225 Pro Max/Super Magnum ECU Calibration

Mercury Hi-Performance has discovered that some 2.5 Litre 225 outboards have been released with the wrong calibration in the Electronic Control Unit (ECU).

Serial Numbers affected are: D936163 thru G205457

a - Paint Black Dot Here

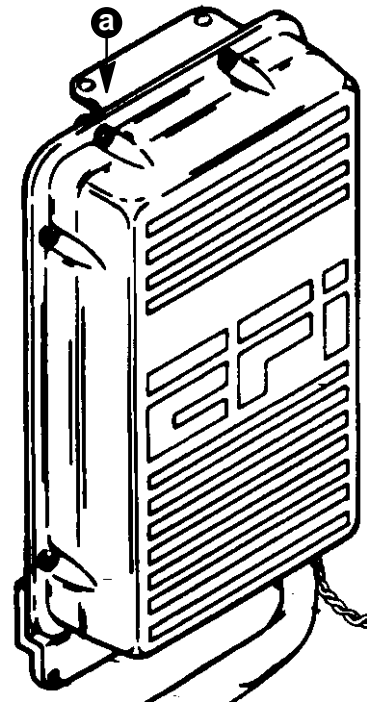
Any ECU that passes the Analog test should have a black dot painted in the location shown. All recalibrated boxes will be marked in the same way.
